## **Frodsham Solar**

### **Response to Local Planning Authority and Statutory Environmental Body Relevant Representations**

PINS Ref: EN010153

Document Ref: EN010153/DR/8.5

TITLE  
**Proposed Crossing CP22  
Elevation & Sections**

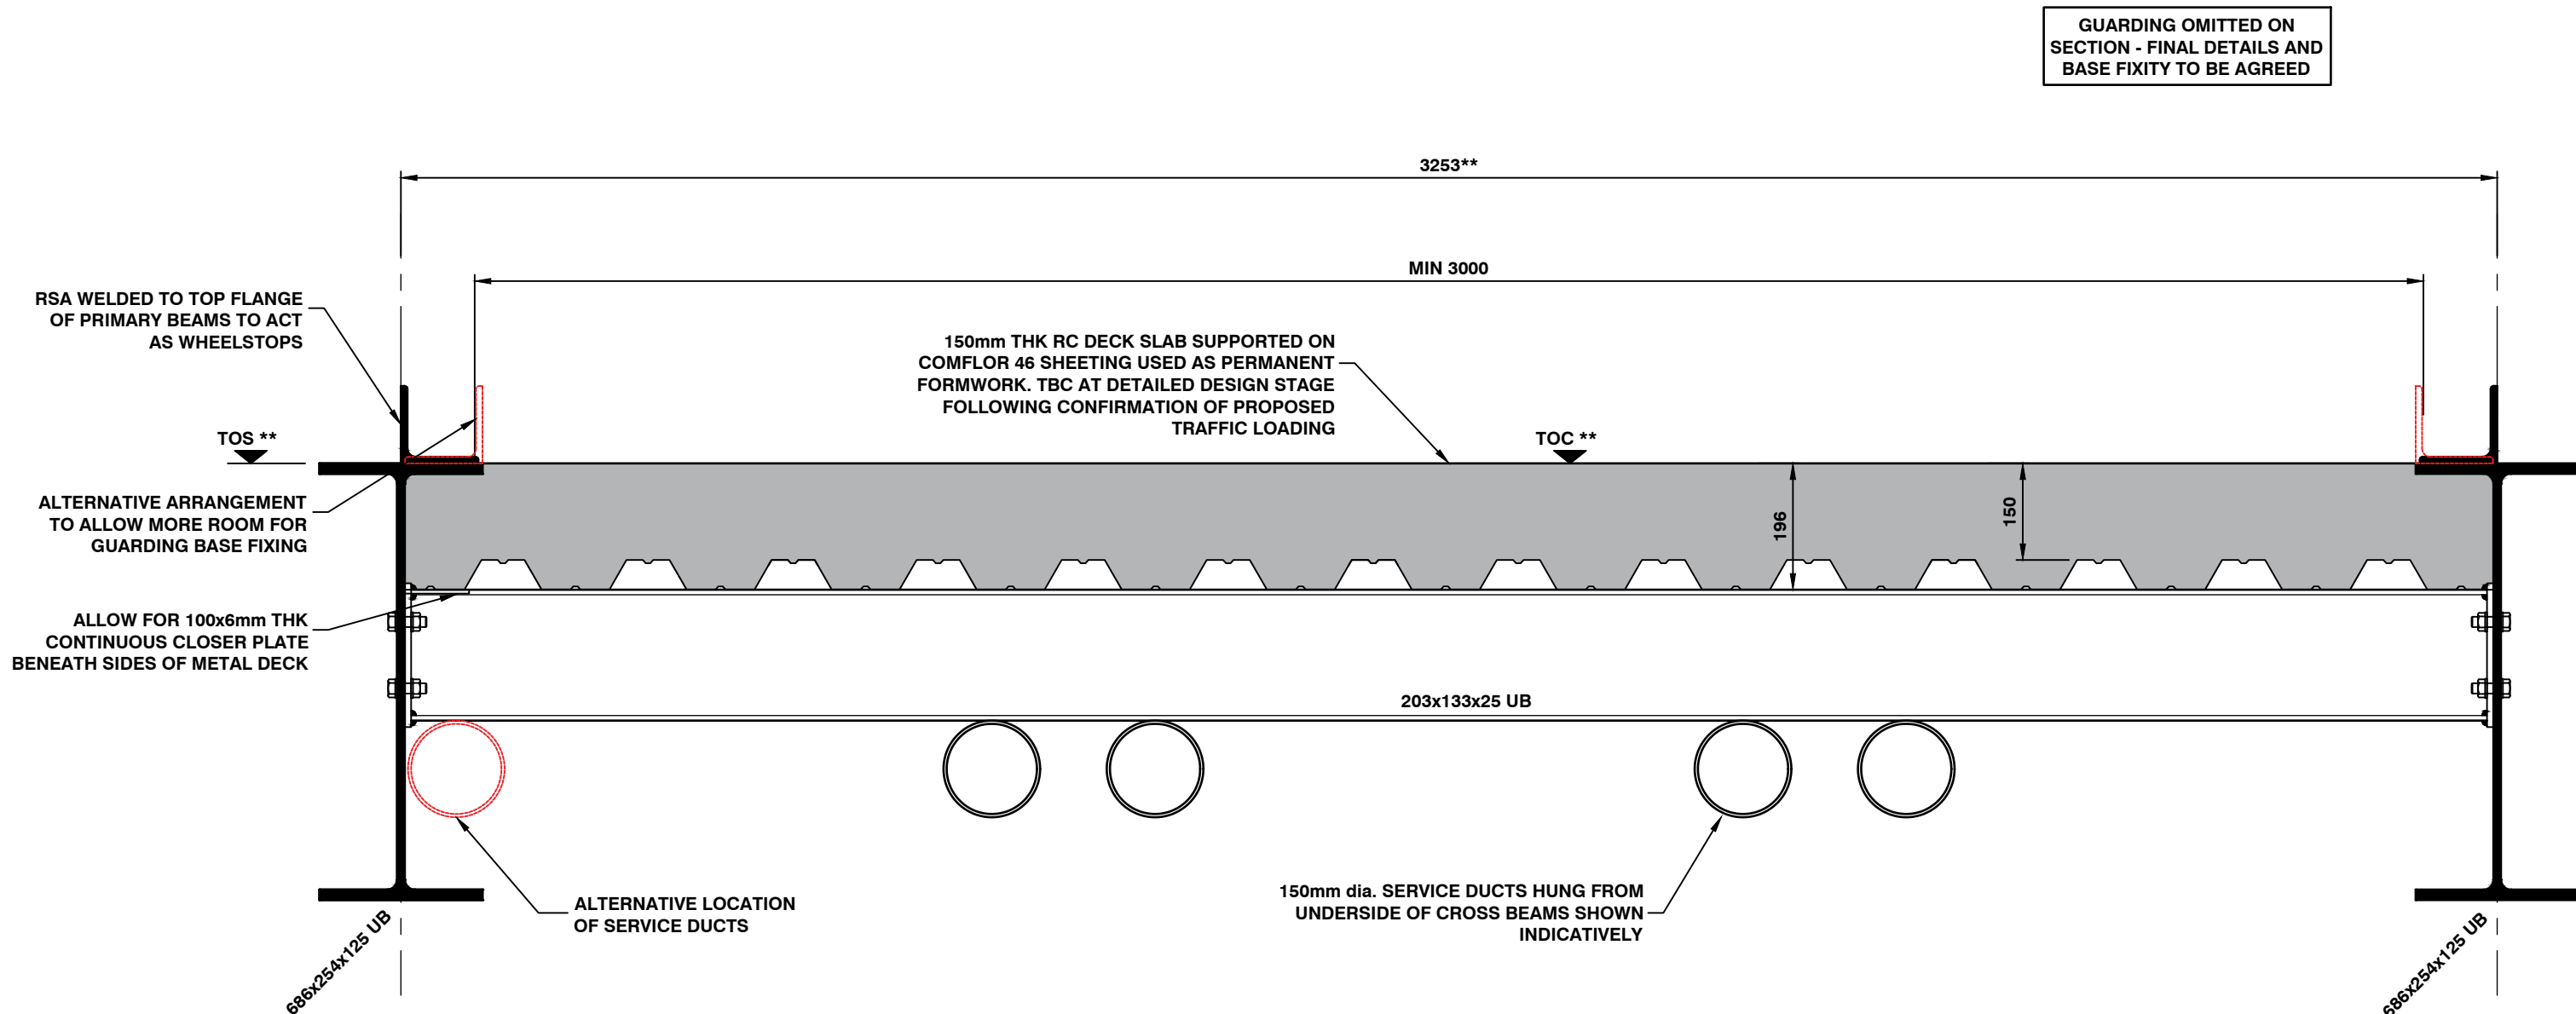
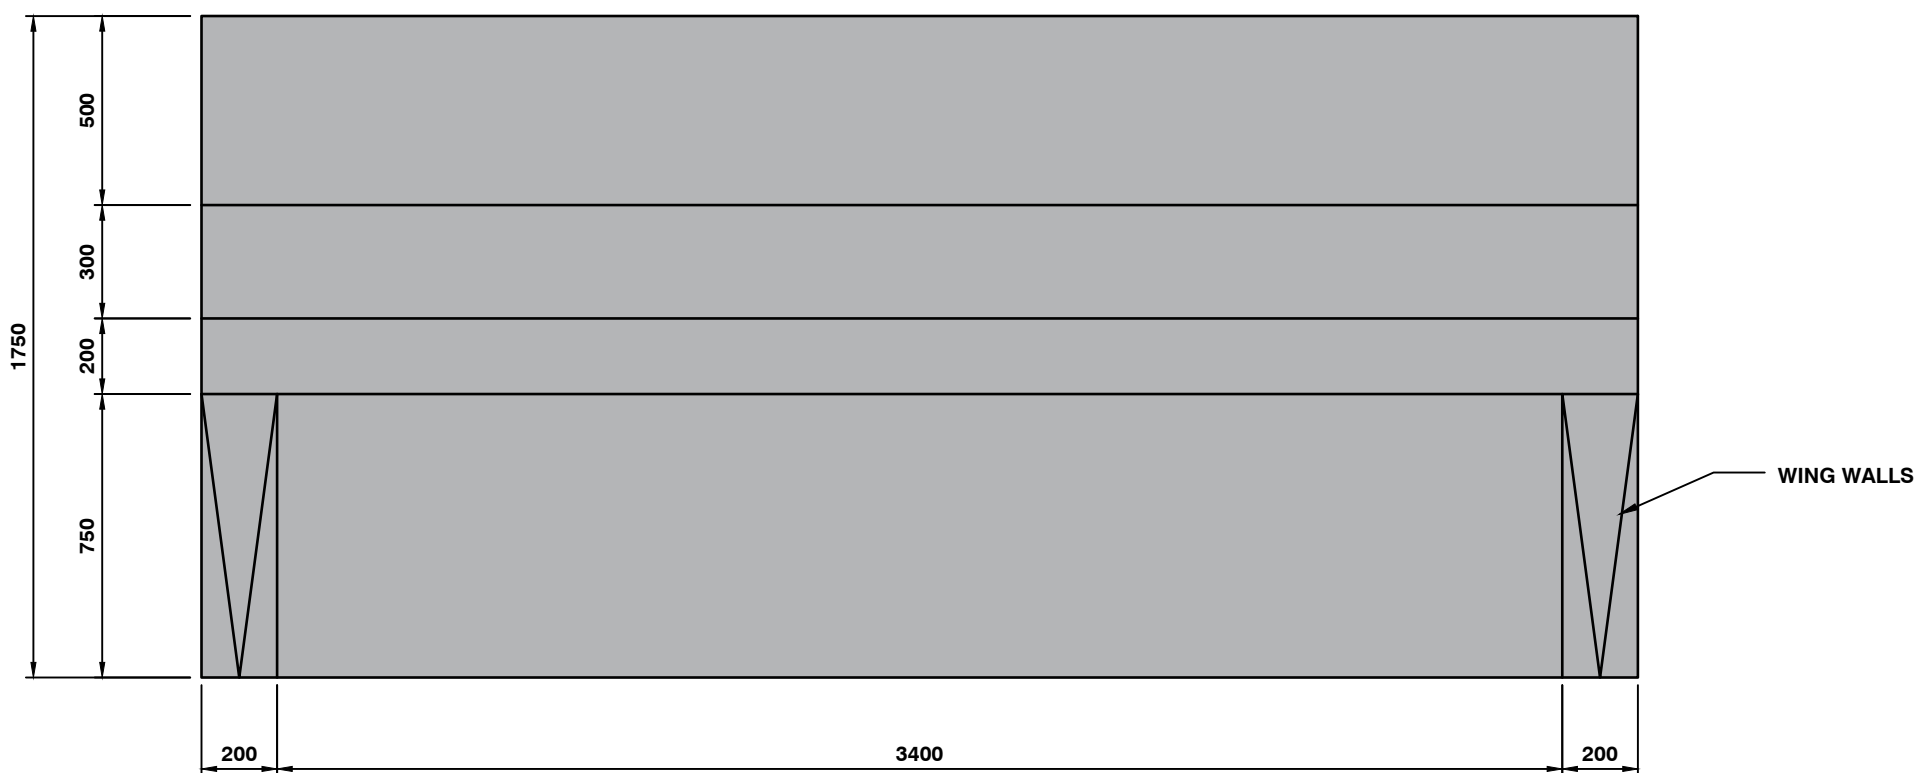
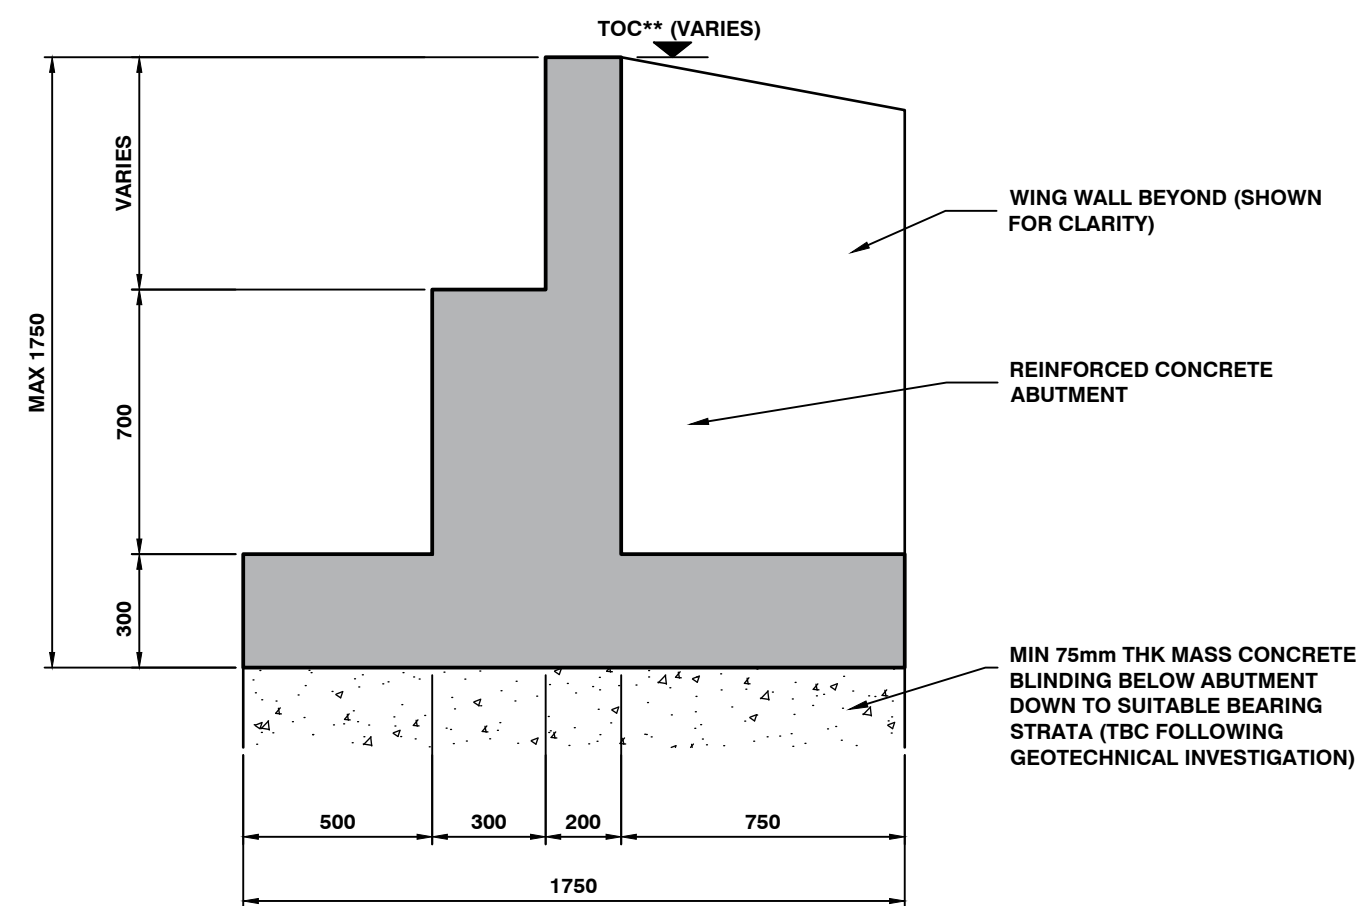
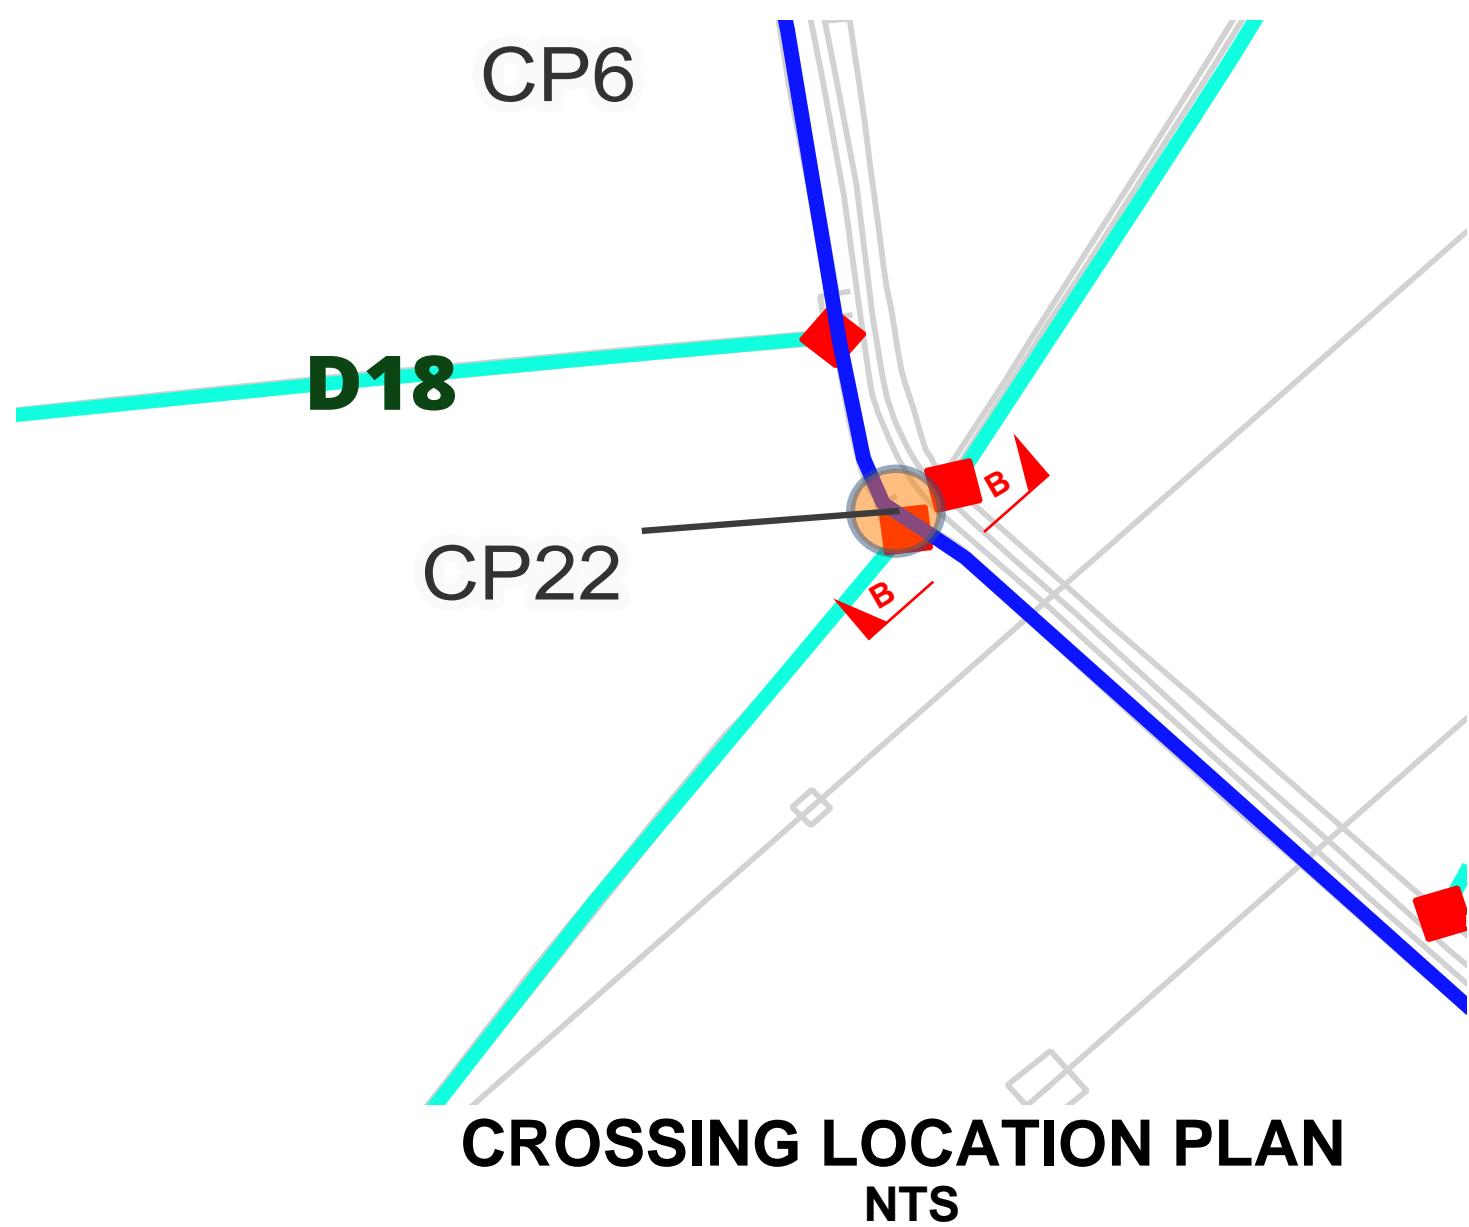
<b>Section/ pages/ table reference:</b>  Figure 2-5j (APP-042)  Table 5-3 (APP-136)	<b>Issue</b>	The position of bridge abutments and soffit level.
	<b>Impact</b>	Will reduce conveyance of water during high flow conditions, preclude access to, and threaten the stability of the riverbanks.  Additionally, this may cause damage to ecological processes and species, leading to a deterioration in WFD water quality.
	<b>Solution</b>	Setback bridge abutments at-least 2m from the bank top edge and increase the soffit level to at least 0.6metres higher than the top of the bank on both sides of the river.  Either through a commitment, or a requirement in the DCO, we require the following: <ul style="list-style-type: none"> <li>• Detailed drawings of crossings for each main watercourse (to scale including the design flood level + 600mm above bank level, as stated in guidance).</li> <li>• Drawings of existing culverted crossings at CP14 and CP22</li> <li>• Confirmation of the width of the deck of each crossing</li> </ul>

Figure 2-5j – Indicative Permanent Watercourse Crossings is observed to have bridge abutments on/close to the bank top edge.

REFER TO TECHNICAL NOTE 14740-WCD-XX-XX-TN-S-001 FOR COMMENT ON INTERITY OF STRUCTURE SUBJECT TO HYDRAULIC (AND OTHER ASSOCIATED) ACTIONS FOR THE 0.5% AEP TIDAL FLOOD EVENT.

ABUTMENTS SET BACK MIN 2m FROM TOP OF EXISTING BANK AND MIN 600mm FREEBOARD ABOVE EXISTING TOP OF BANK LEVEL (WHERE PRACTICALLY POSSIBLE). PRINCIPLES APPLY TO ALL NEW AND REPLACEMENT CROSSINGS
